ADDENDUM NO. 2

Issued by: Sacramento City Unified School District

Project: 0144-401, Hubert H. Bancroft Playground

2021 PAVING REPAIRS

1 SEALCOAT & CONSTRUCTION PLAN SCALE 1" = 10'-0"

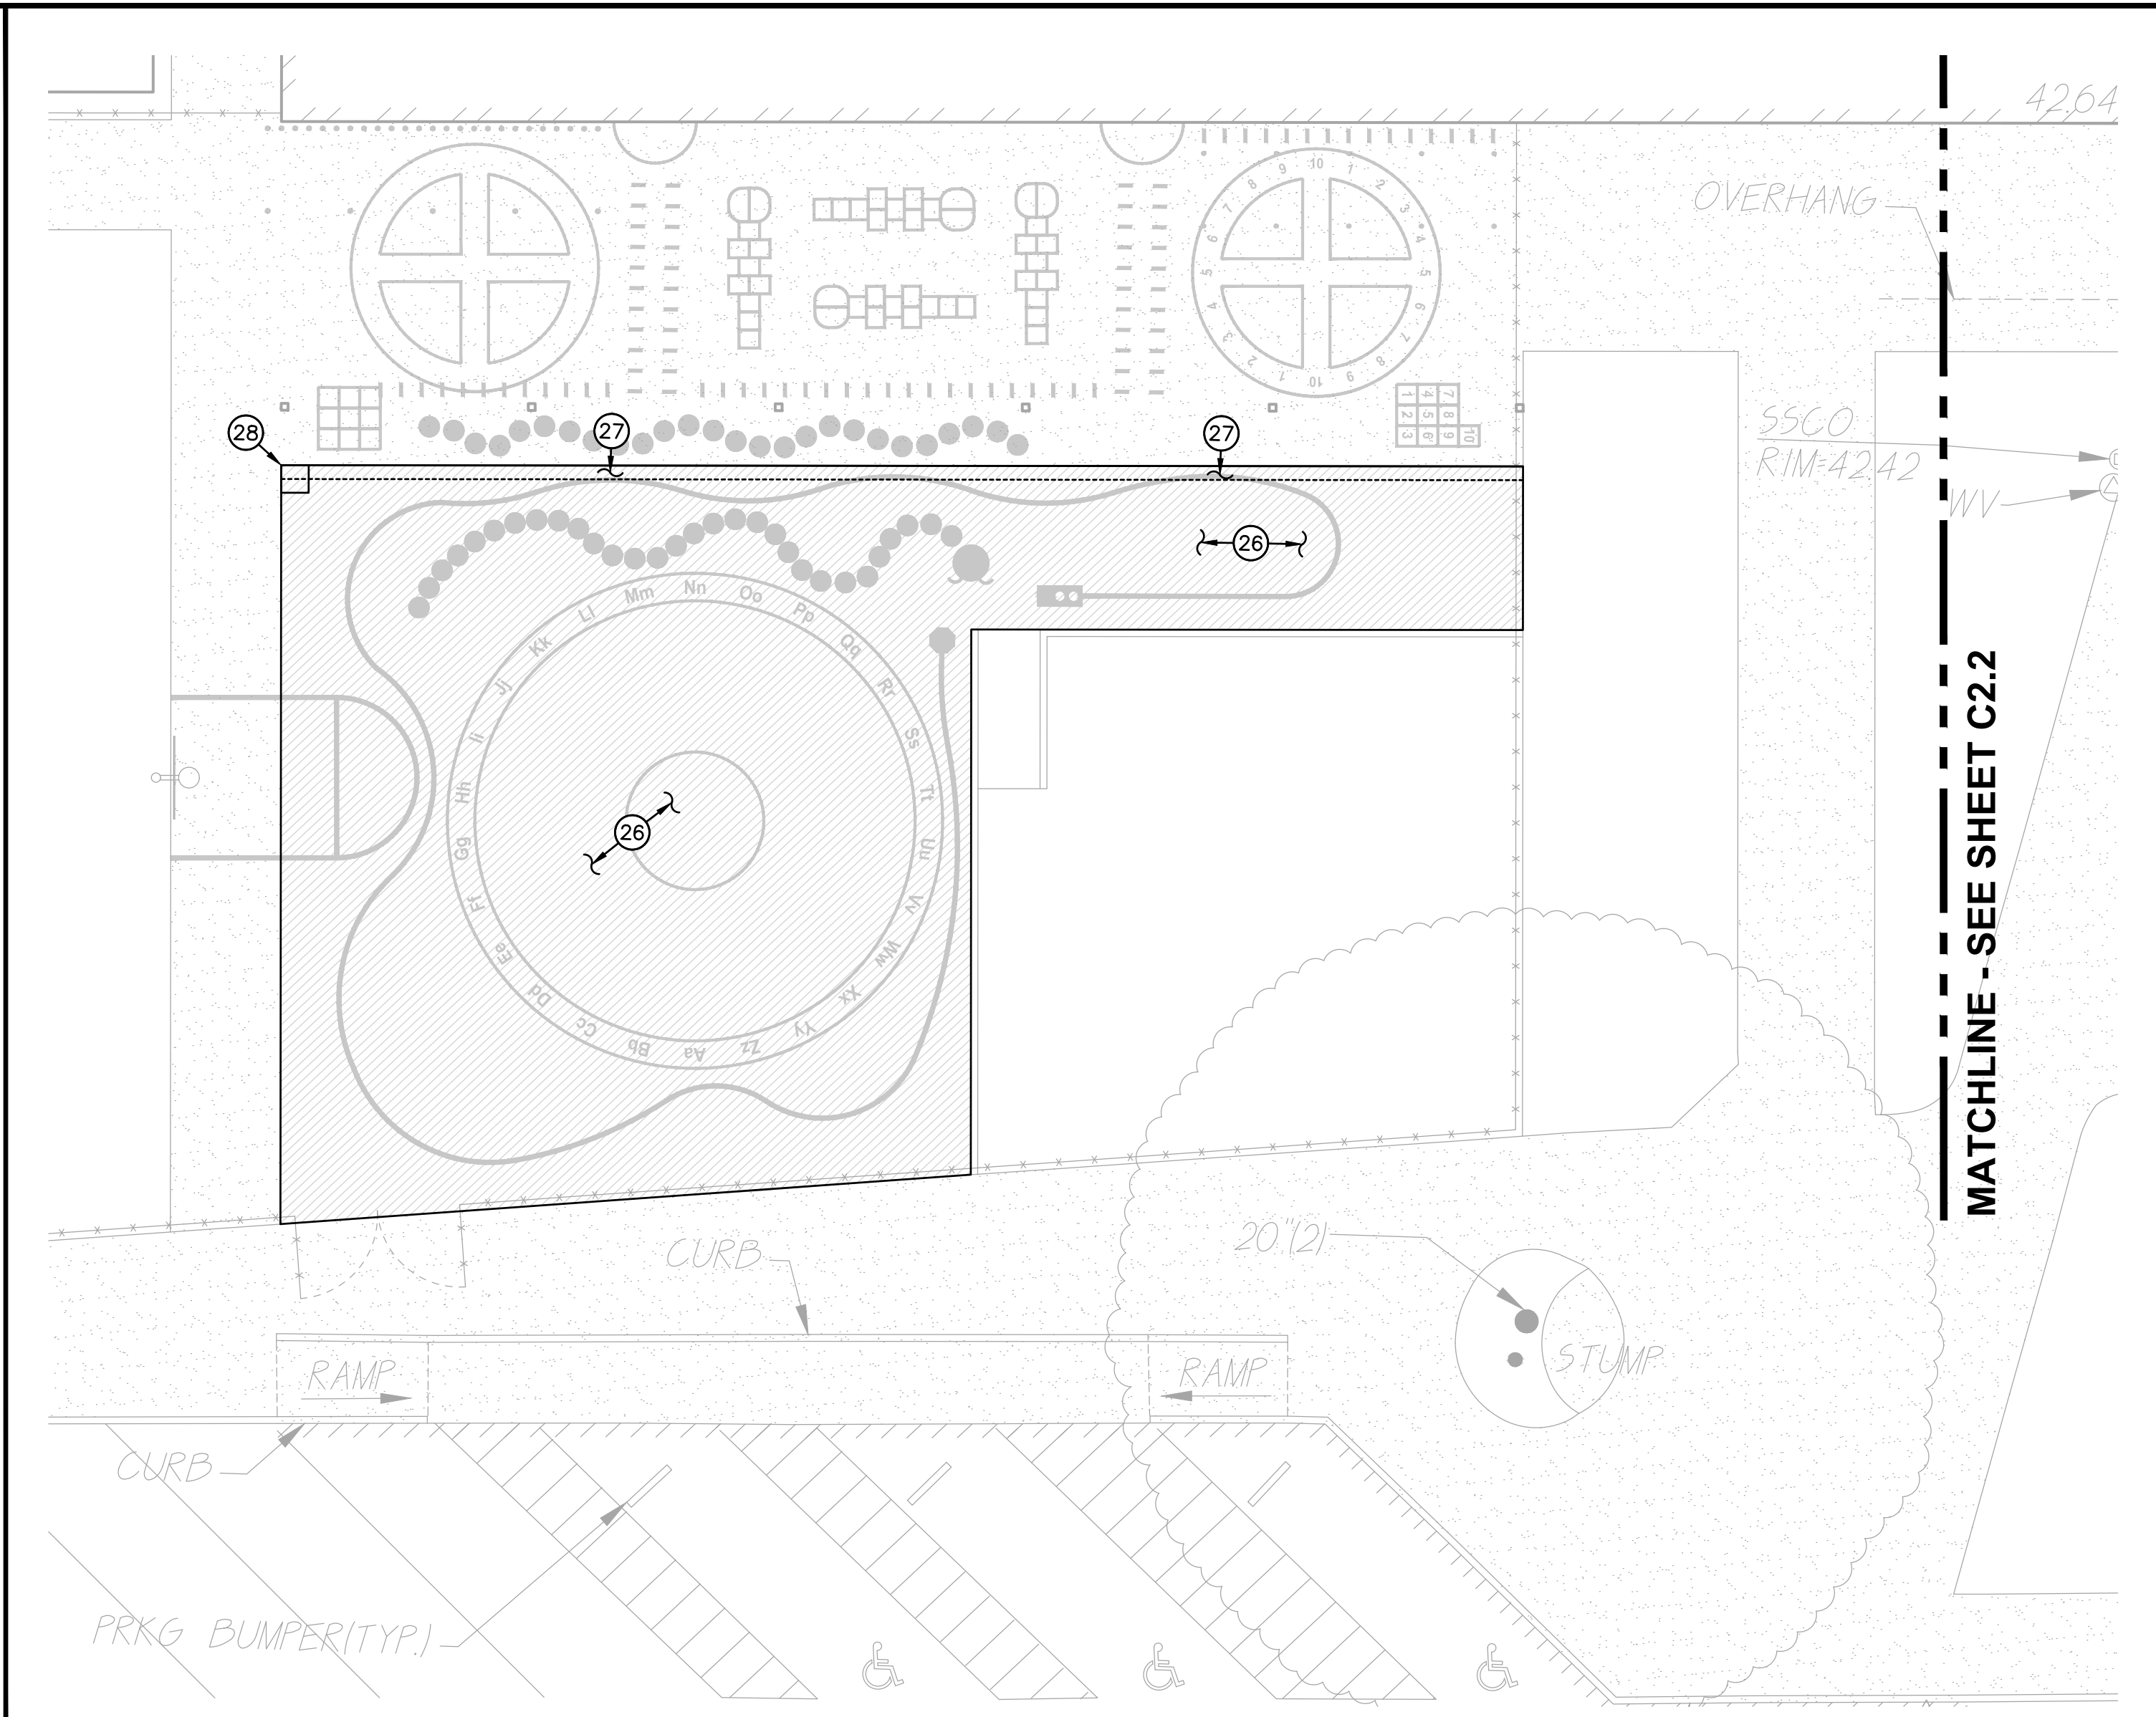
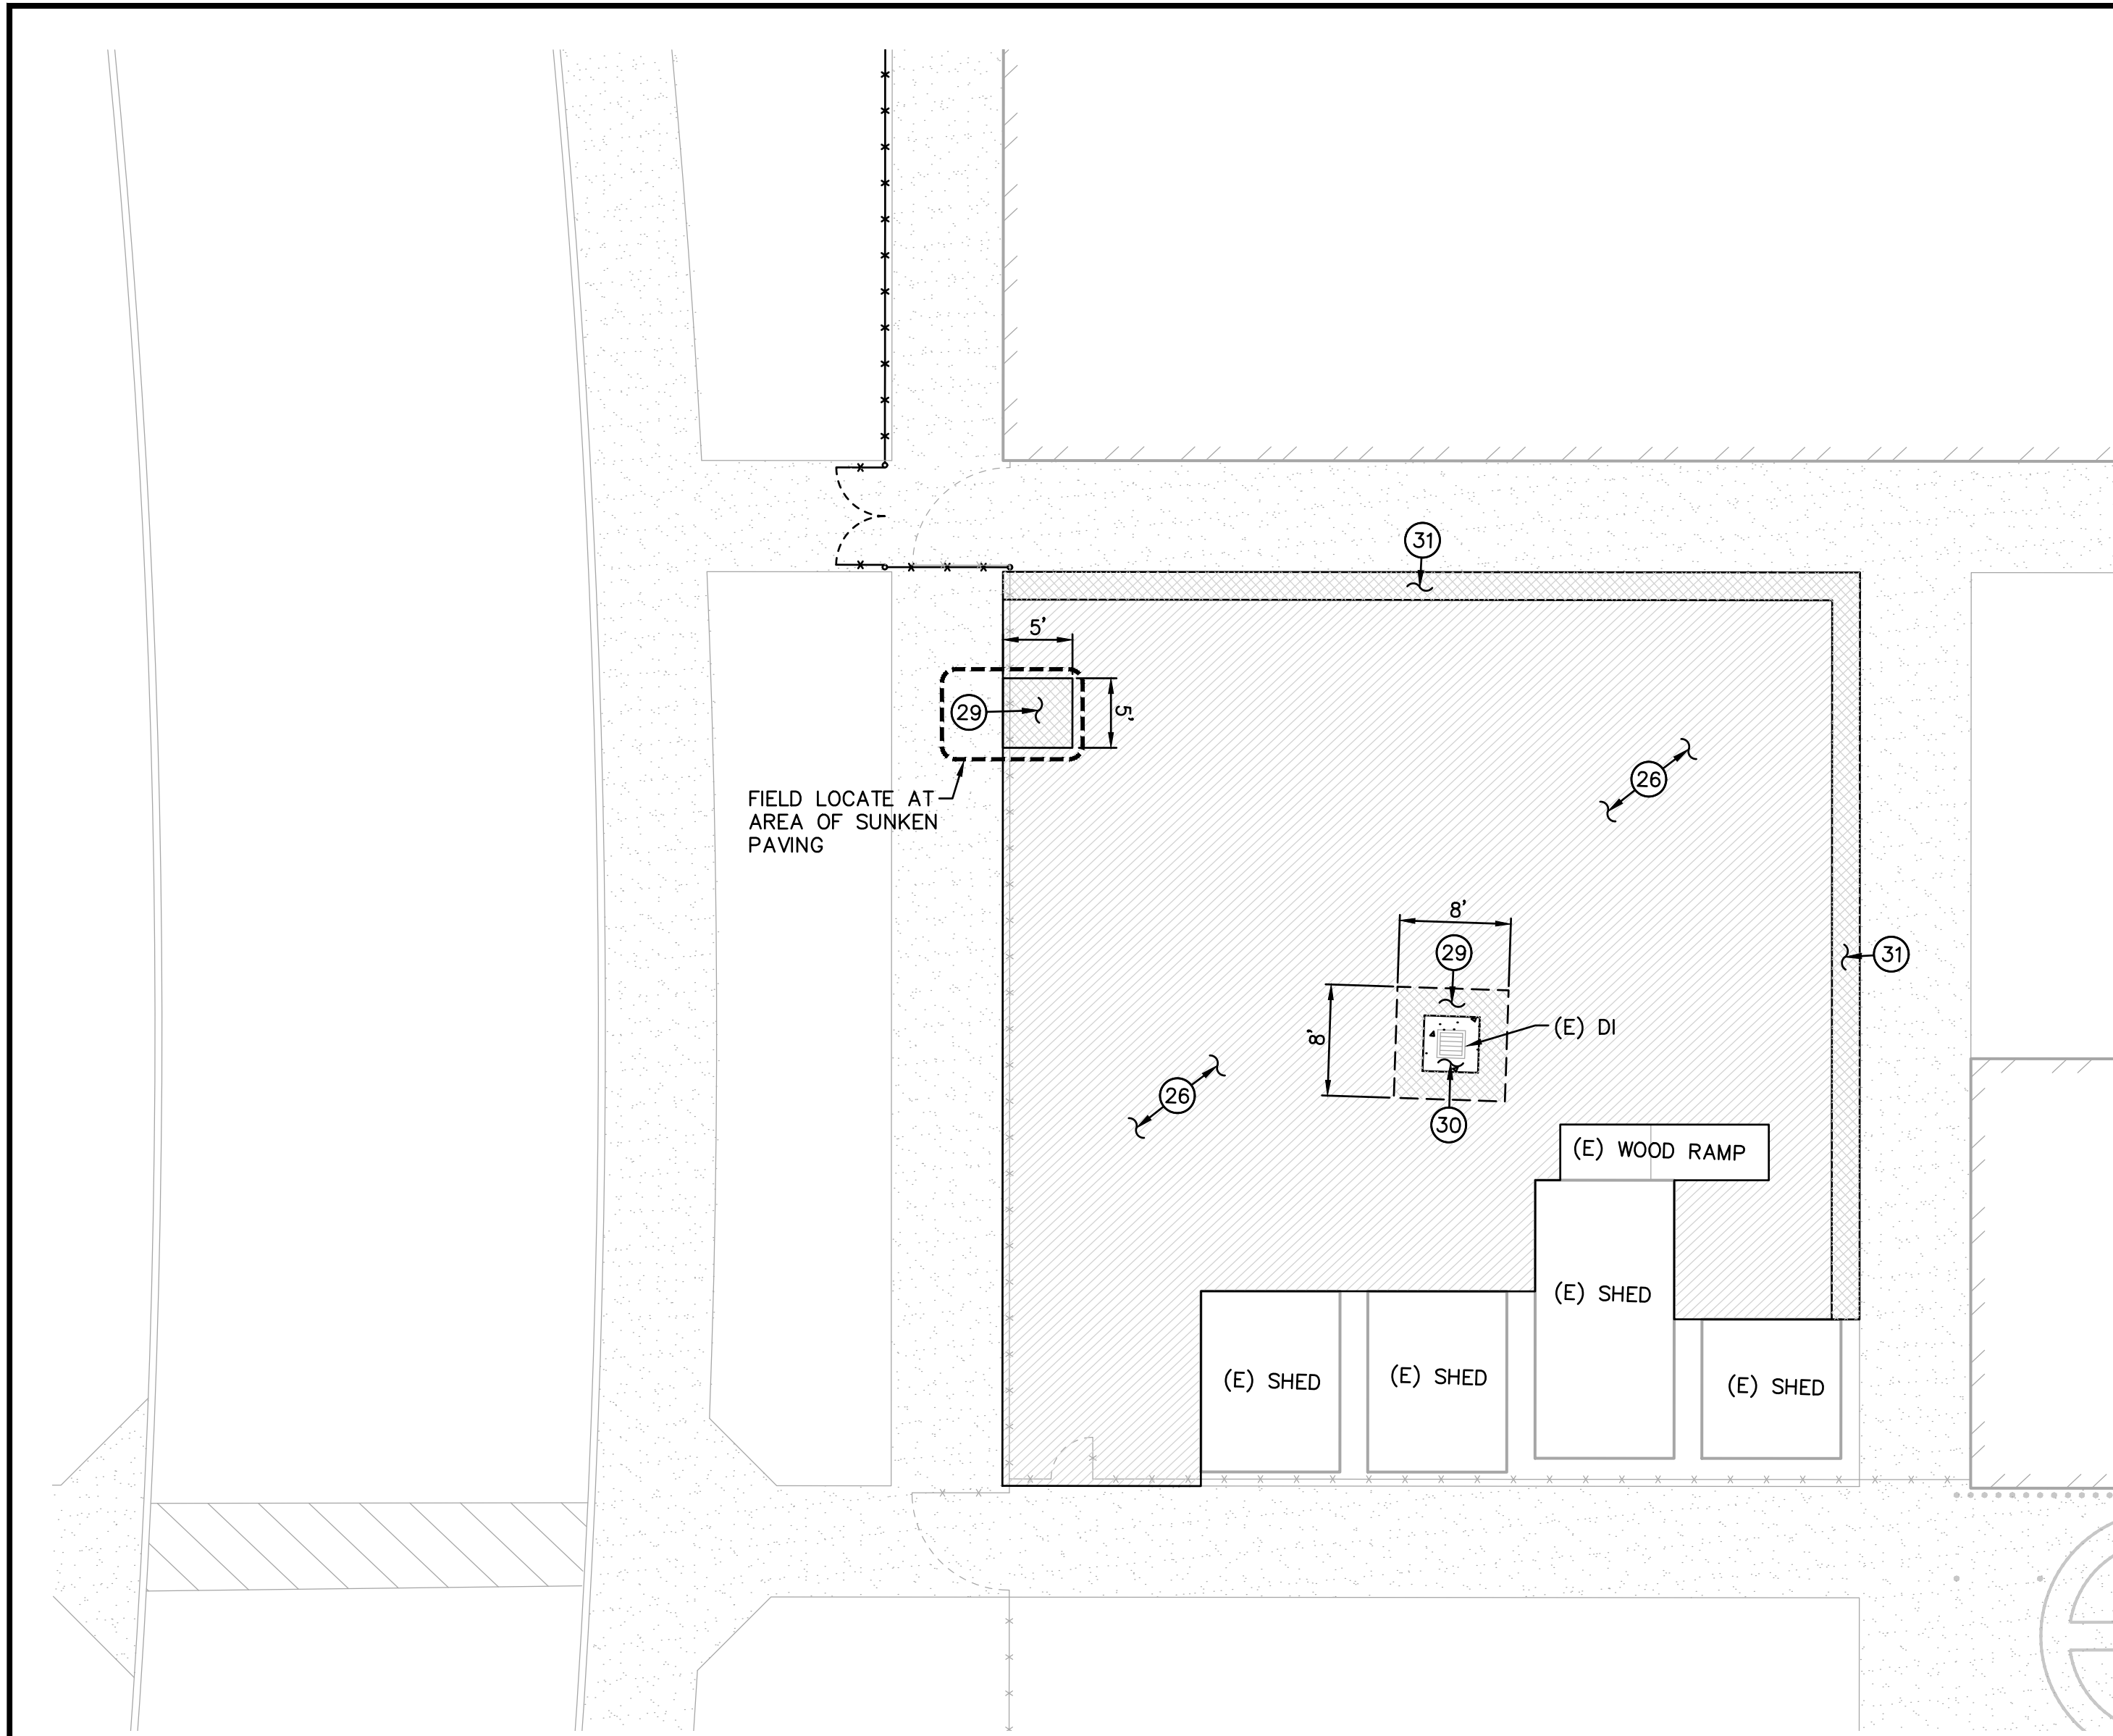
Sealcoat is only required in the Kinder areas shown on sheet C2.3. The majority of these areas are either existing paving where the 30 day cure would be achieved by default, or is minimal patch paving which can be completed early in the project. Should the construction schedule not permit even the 30 day cure time for the patch paving in the Kinder areas, contractor may submit a request (by RFI) for a reduction in the 30 day cure, which will be approved on this project down to no less than 15 days.

C2.3 – Grading Plan (new plan sheet)

1. View 2, previously shown on C2.2, is now shown on this sheet.
2. View 2 has been updated to reflect some edge grinding to remove a lip in the pavement at the edge of the concrete. Construction note 27 has been added to describe the proposed work.

3. View 2 has been updated to reflect the removal and patch of an existing in-ground hose bib. Construction note 28 has been added to describe the proposed work.

4. New view 1 depicts additional requested crack fill and sealcoat scope to be included in the project. Construction note 26 has been added to describe the proposed work.

5. New view 1 depicts some sawcut and patch of a 5'x5' pavement area near the existing 4' tall fence line. Construction note 29 has been added to describe the proposed work.

6. New view 1 depicts sawcut and patch of a 24" strip of ac along the edge of walks to eliminate the deteriorated paving along this edge. Construction note 31 has been added to describe the proposed work.

1. New view 1 depicts sawcut and patch of the paving around an existing drain inlet and patch back with a concrete apron and patch AC paving. Construction note 30 and 31 have been added to describe the proposed work.

- GRADING NOTES**
- 27. PRIOR TO SEAL COAT, LIGHTLY SURFACE GRIND EXISTING PAVING ALONG EDGE OF PAVING TO A FLUSH CONDITION TO REMOVE "LIP" TRIPPING HAZARD.

- 28. SAWCUT AND REMOVE 24"x24" SQUARE OF PAVING AND EXISTING CONCRETE AND HOSE BIB. CUT AND CAP WATER PIPE. EXCAVATE BASE AND SOIL AS NEEDED FOR NEW SCETION. PATCH BACK WITH 3" AC OVER 8" CLASS II AB ON SCARIFIED AND RE-COMPACTED SUBGRADE.

- 29. SAWCUT AND REMOVE 24" WIDE STRIP OF ASPHALT AROUND DRAIN INLET AS SHOWN. REMOVE AC, BASE ROCK AND SOIL AS NEEDED FOR NEW SECTION. PLACE 3" TYPE B (3/8" MAX) ASPHALT PAVING OVER 8" COMPACTED CLASS II AB OVER 8" DEEP SCARIFIED AND RE-COMPACTED SUBGRADE. (10" TOTAL SECTION)

- 30. EXCAVATE AND POUR 12" WIDE, 6" DEEP CONCRETE COLLAR OVER 5" CLASS II AB ON 8" DEEP SCARIFIED AND RE-COMPACTED SUBGRADE. (10" TOTAL SECTION)
 - 31. SAWCUT AND REMOVE 24" WIDE STRIP OF ASPHALT PAVING ALONG EDGE OF HARDCOURT. RE-COMPACT BASE ROCK AND PLACE 3" TYPE B (3/8" MAX) ASPHALT PAVING OVER EXISTING BASE. PROVIDE SEALCOAT THIS AREA.

8 NOT USED NO SCALE

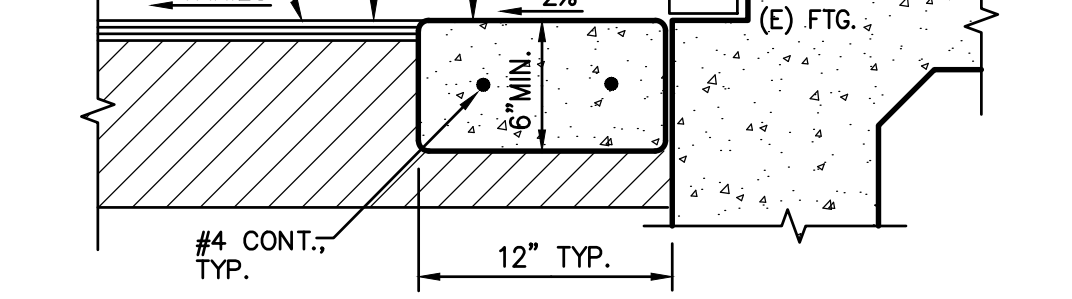
C6.1 – Drainage and Utility Plan

1. Per bid comment, detail 8 has been eliminated from the plan. The work related to this detail was previously removed from the scope and this detail is no longer needed.
